CITY PLAN COMMISSION STAFF REPORT

CD-CPC-2025-00133

Executive Park Lot 6 Major Amendment

Rezoning to UR - Major Amendment

BUILDING ELEVATIONS

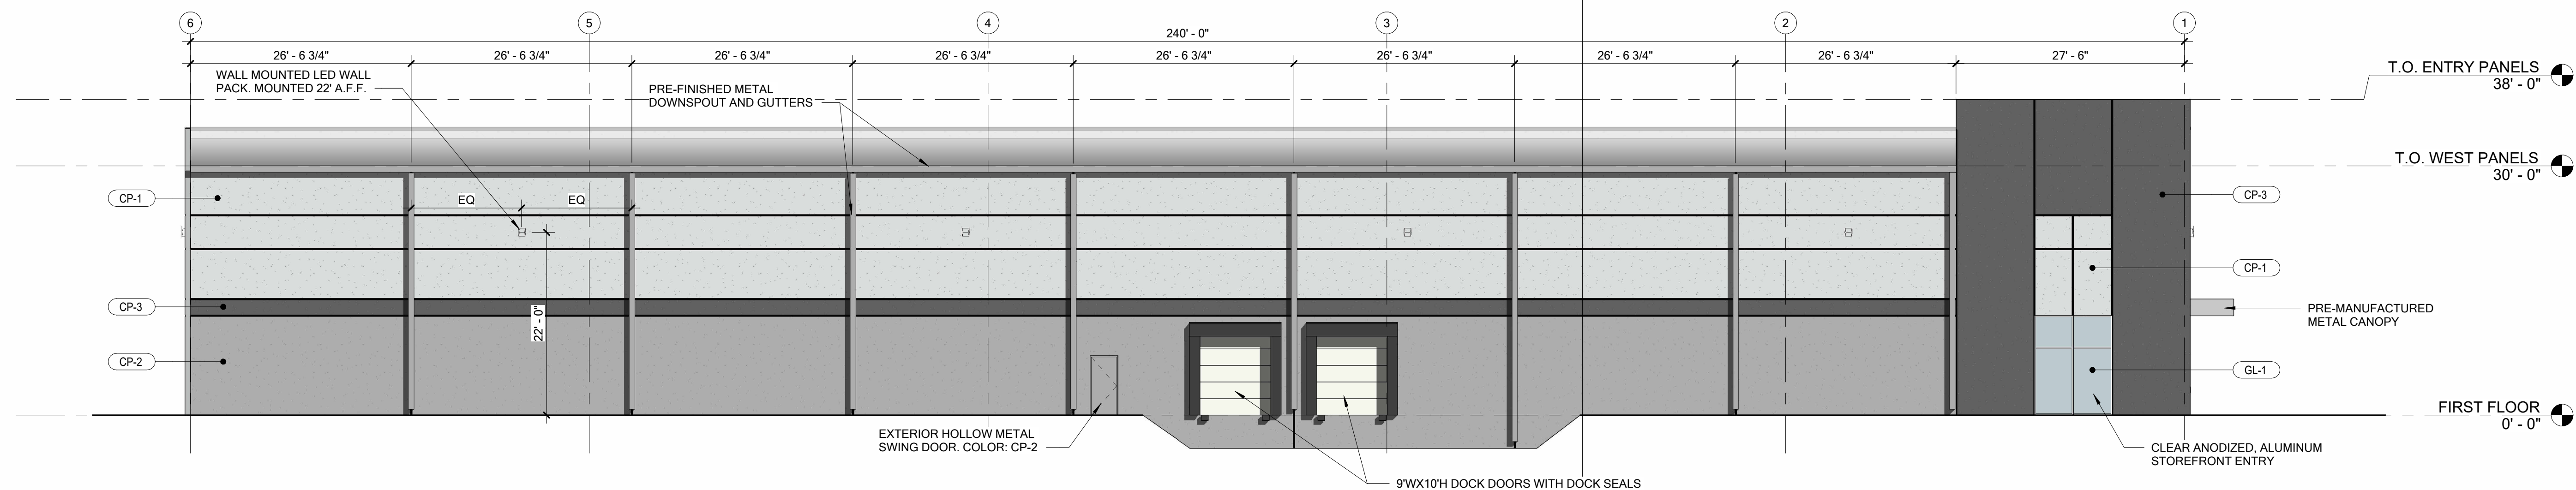
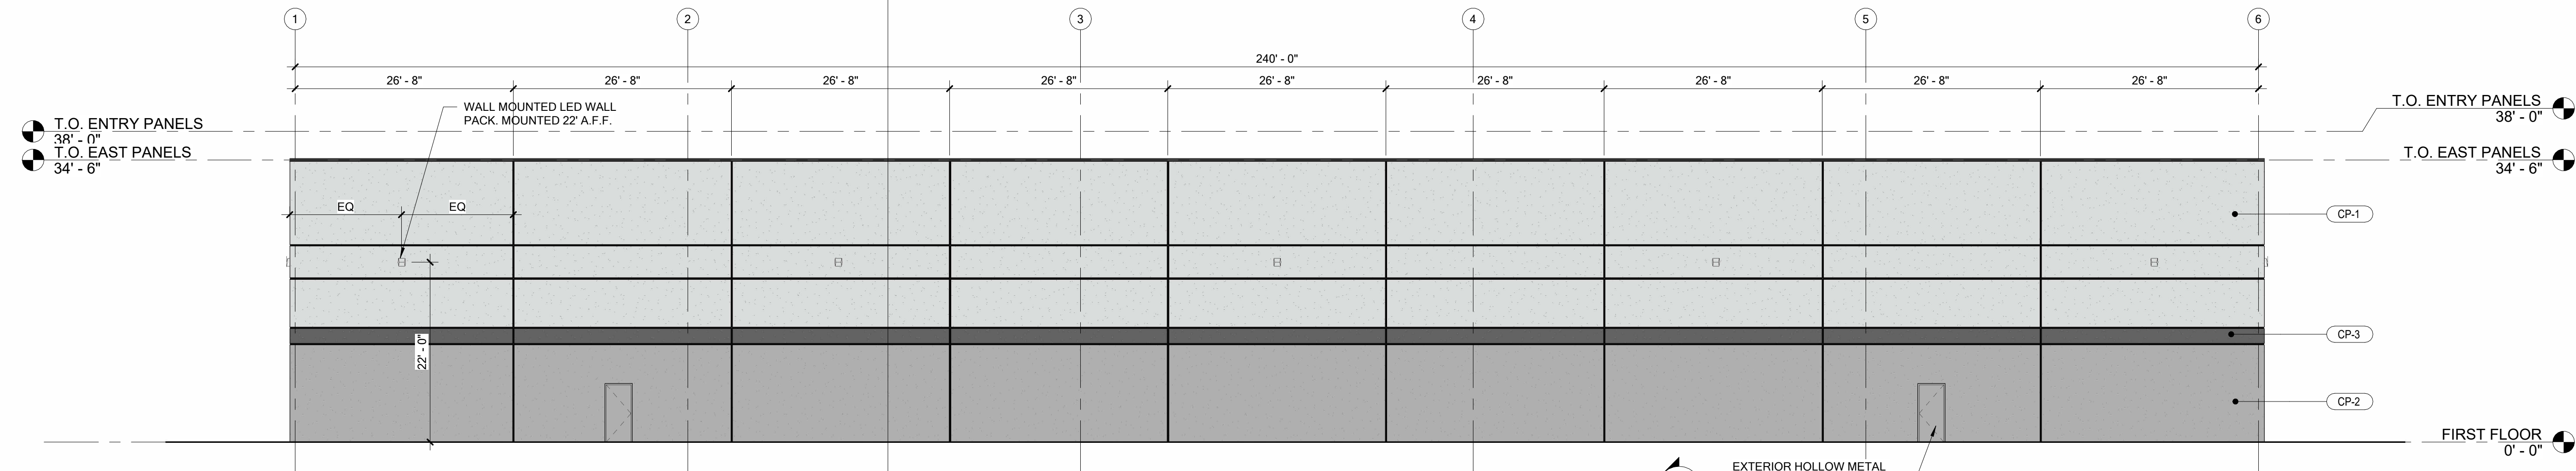
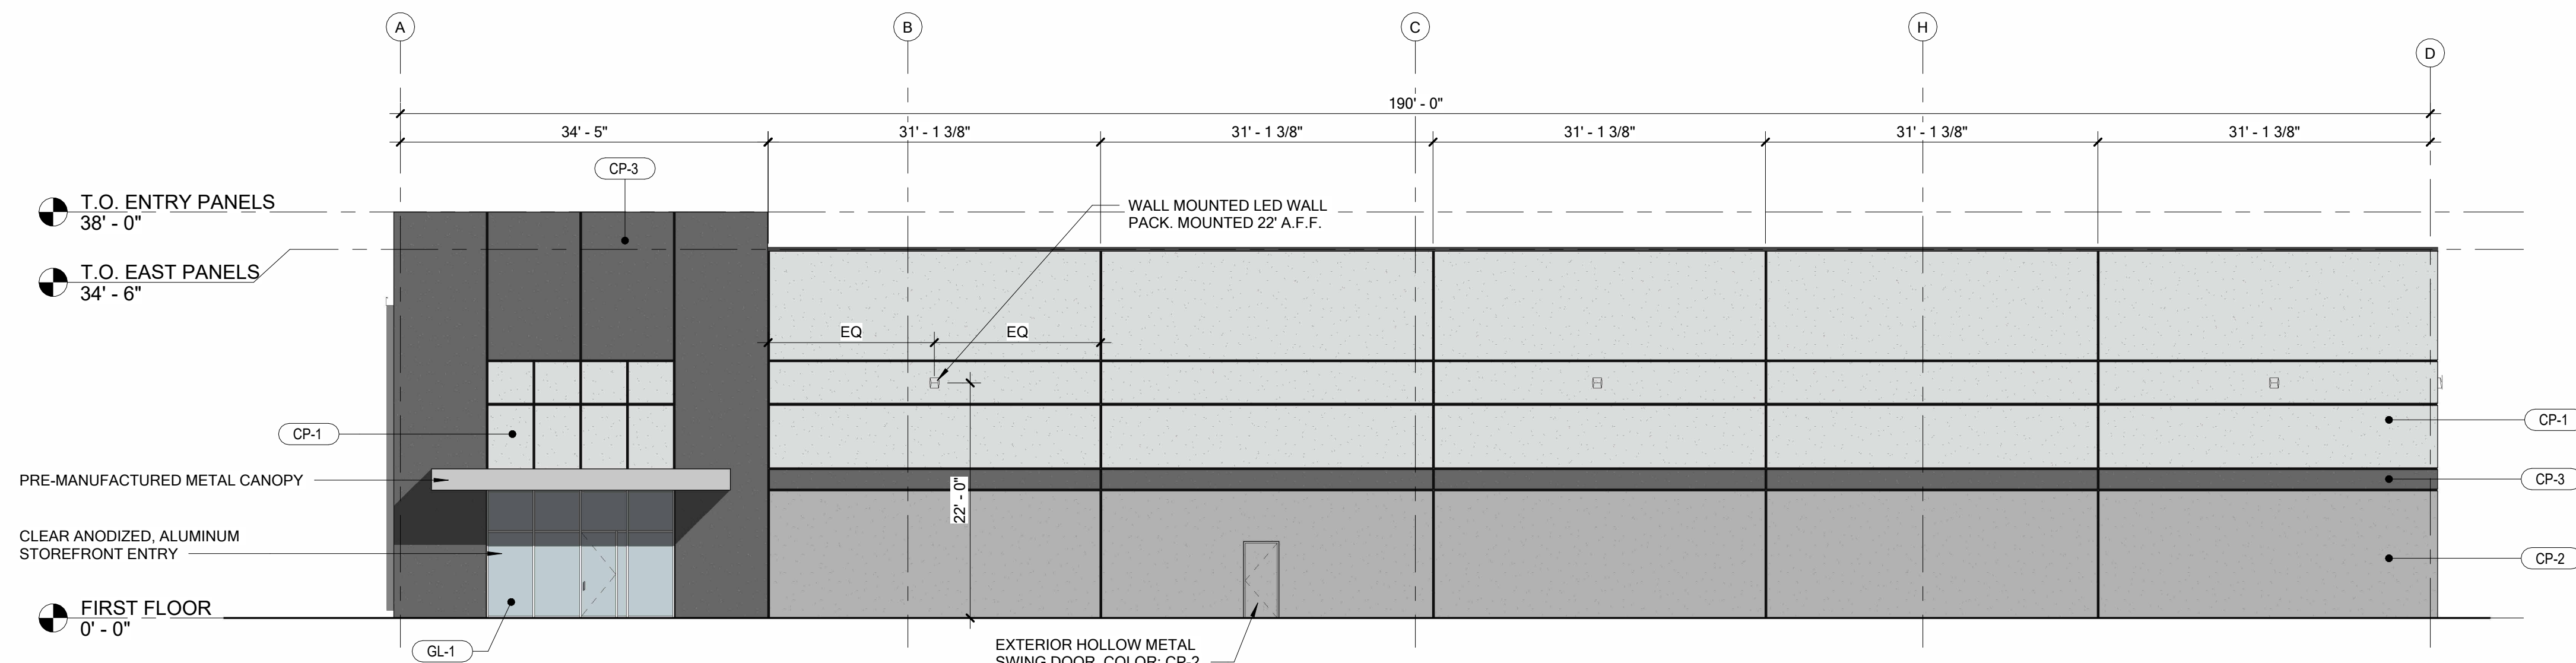
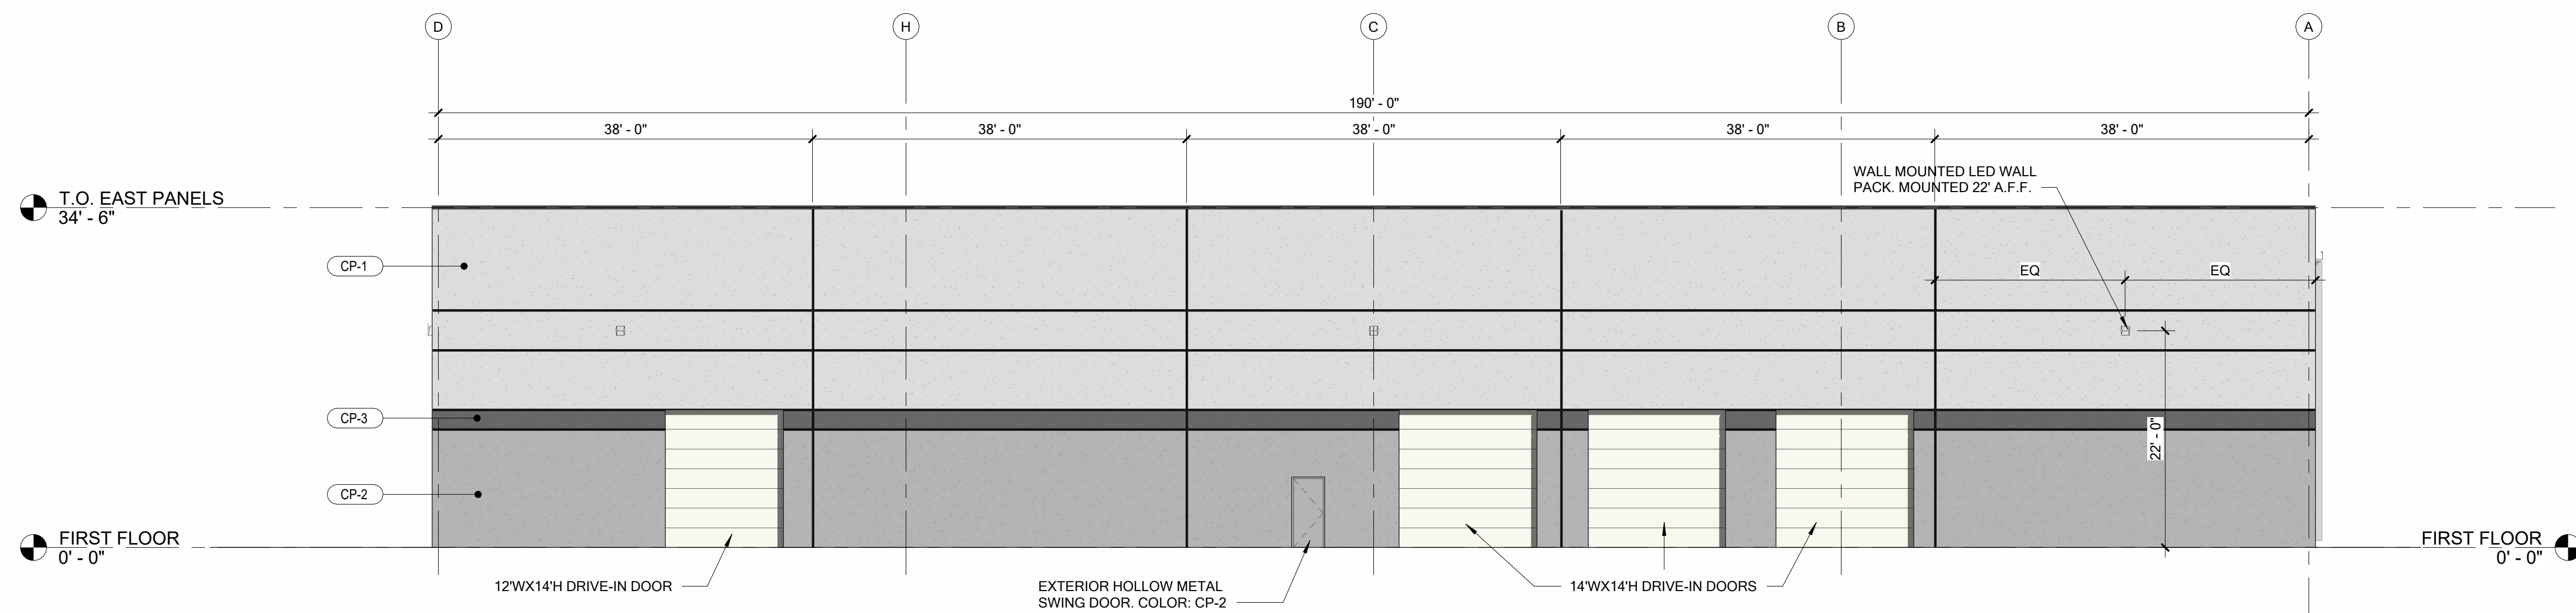
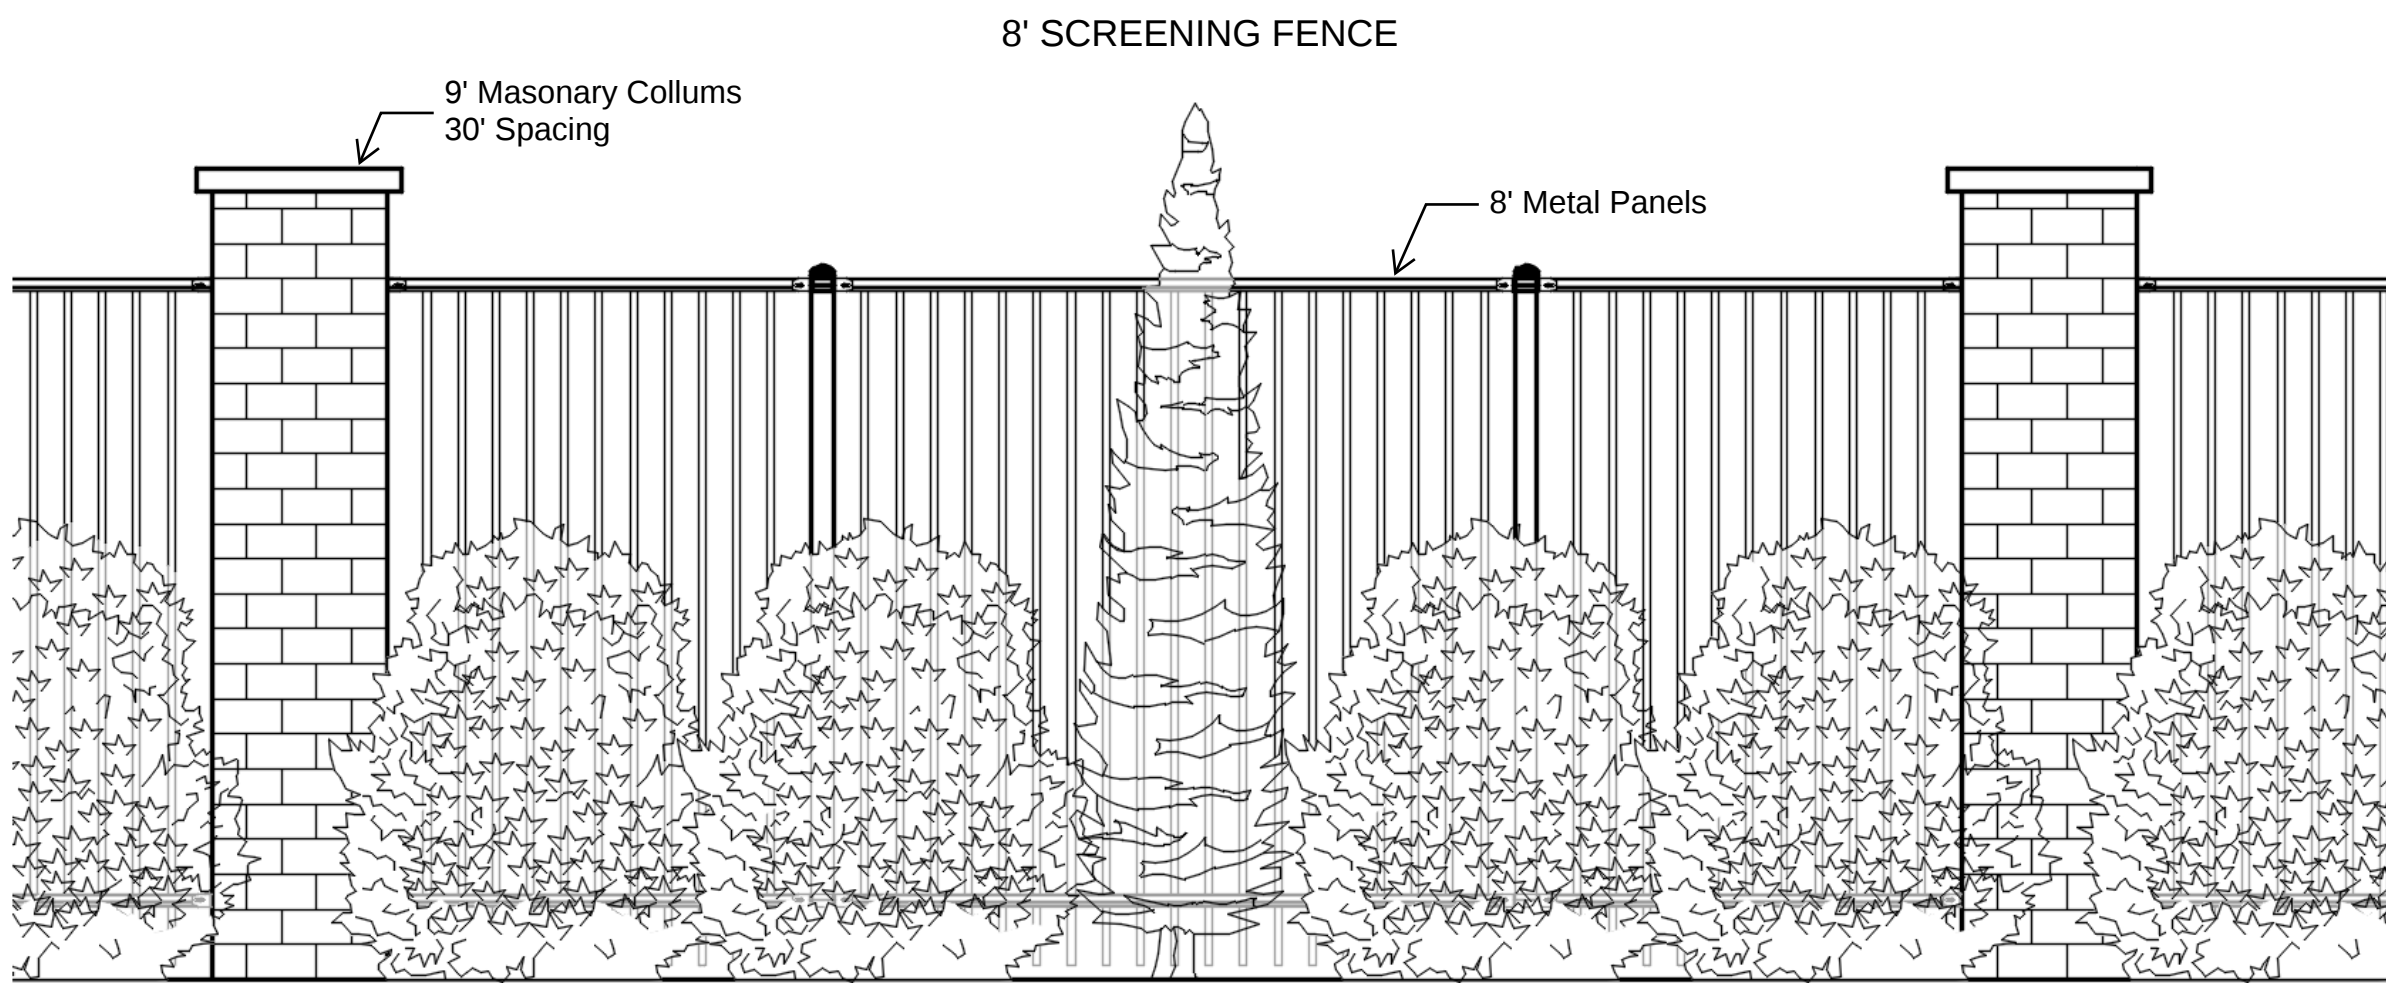
This site is appropriate for light industrial uses, but the applicant should keep in mind that the neighboring use is a charter school. To improve the project’s Playbook and Area Plan alignment regarding design, the building should have large windows on all four elevations. The concern is that no one inside the building can see if there’s an issue outside the building. Additionally, the applicant should include the robust fencing and landscaping shown in the

first submittal even though it was left out of the second submittal. – Luke Ranker, Community Planning Division, 4th District Planner

The area the property is located in is mostly developed with larger buildings. The applicant has provided proposed elevations. Staff requested the applicant provide windows along the rear of the building, however the applicant decided to move forward with the elevations submitted.

Evaluation	Goal	Notes
High		
Medium	CC HE SEG	CC – Access to interstate HE – Bioswale adjacent to existing pond SEG – Infill lot
Low	WDC	WDC – building lacks windows on all four sides, second submission lacks rendering showing screening
